1 SITE PLAN 7-10-17
1" = 40'-0"

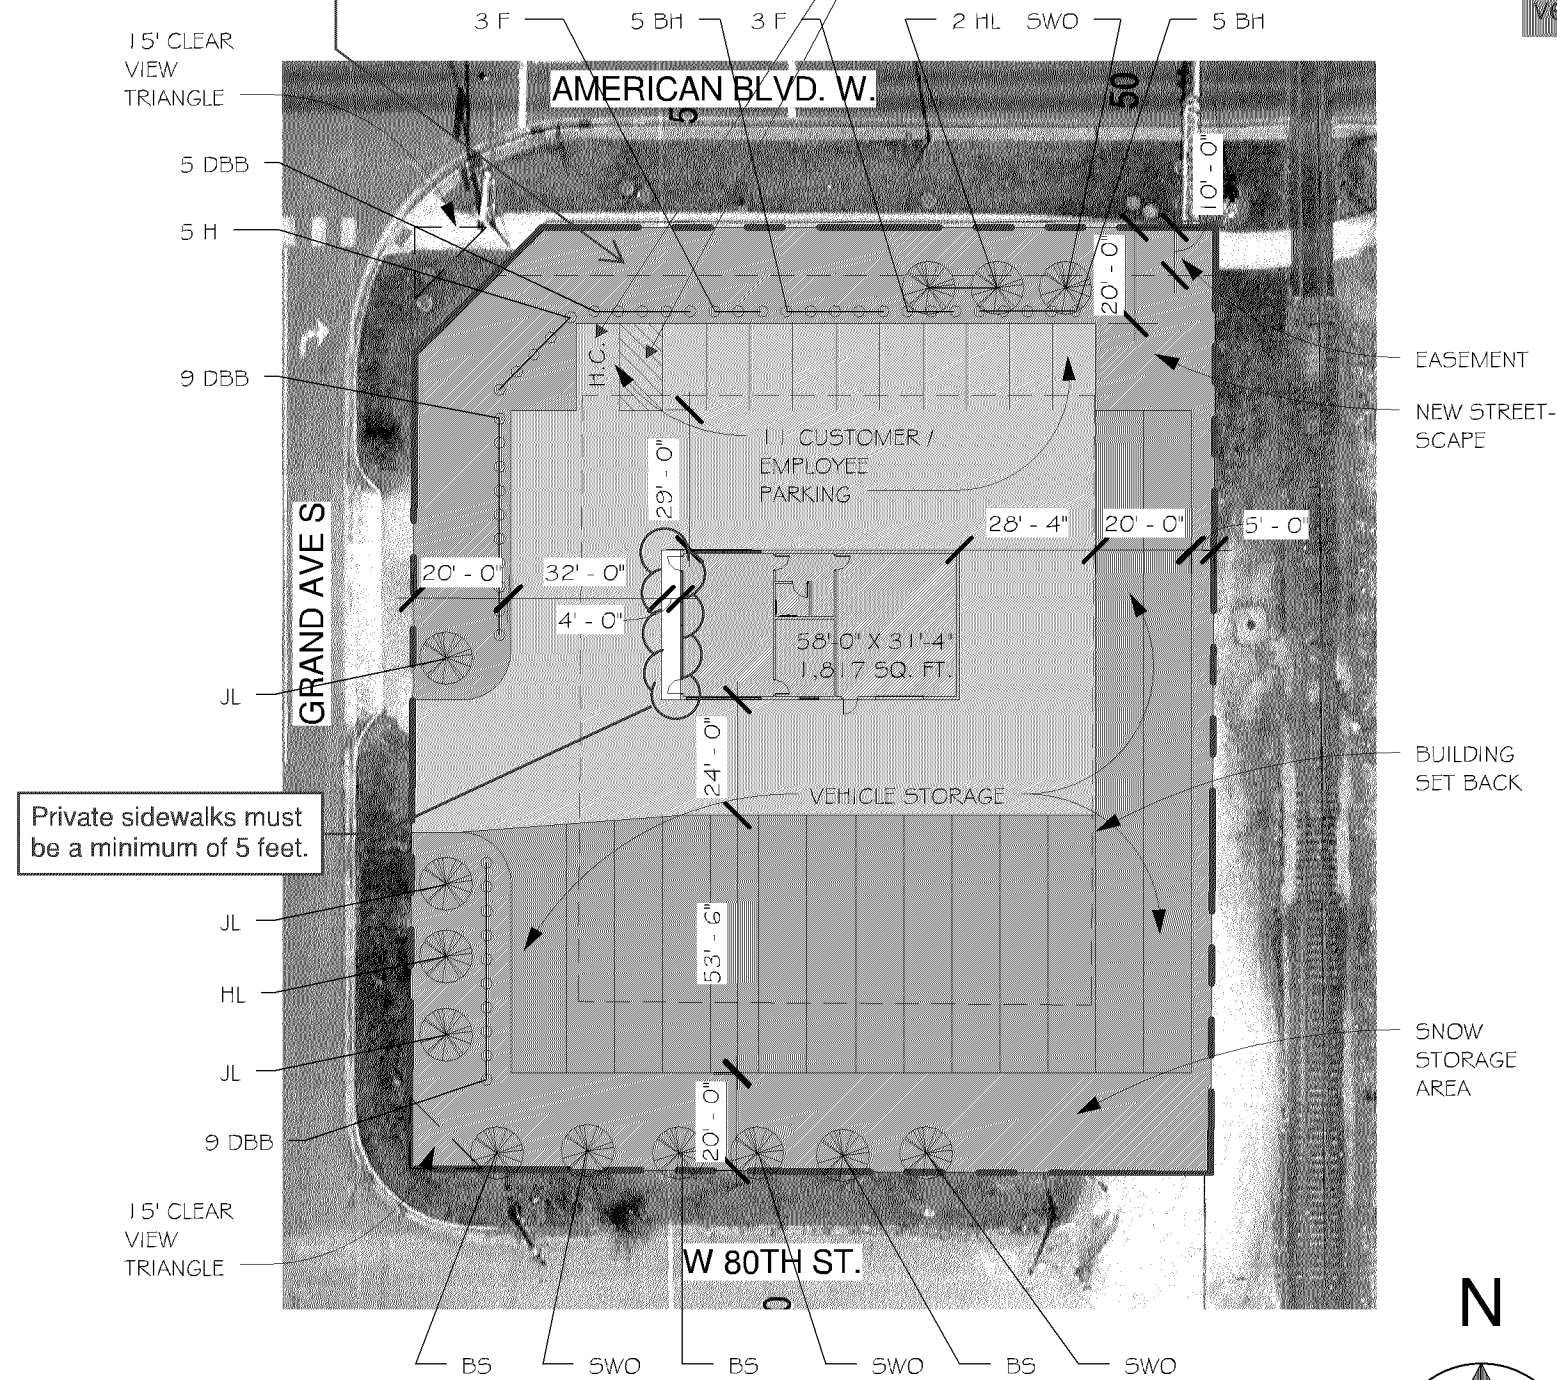
Exterior site lighting must comply with Section 21.301.07 of the City Code. An initial lighting plan and maintained lighting plan with a light loss factor (LLF) of 0.81 must be provided.

Required quantity of parking on-site is 9 parking stalls per Sec. 21.301.06 of the City Code.

A sidewalk connection to the public sidewalk network must be provided per Sec. 21.301.04 of the City Code.

Provide signage on posts for both accessible parking space and access aisle

Provide a hydrant on the site.

Provide emergency vehicle access

Based on a Developable Landscaping Area of 32,418 square feet, City Code requires the site to have 13 trees and 32 shrubs. The quantity of plant material proposed is Code-compliant.

The Landscaping and Screening Policies and Procedures requires that at least 50% of the frontage of a building facing a public street should be landscaped with foundation plantings. Planting beds along the foundation of the building are required.

The Landscaping and Screening Policies and Procedures recommends that the perimeter of sites have visual interest and large paving areas be broken up by landscaping. The majority of the trees proposed are located along the southern and southwestern boundary of the site. The perimeter trees should be better dispersed along the perimeter in order to add visual interest along Grand Avenue and American Boulevard West and better break up the areas of pavement.
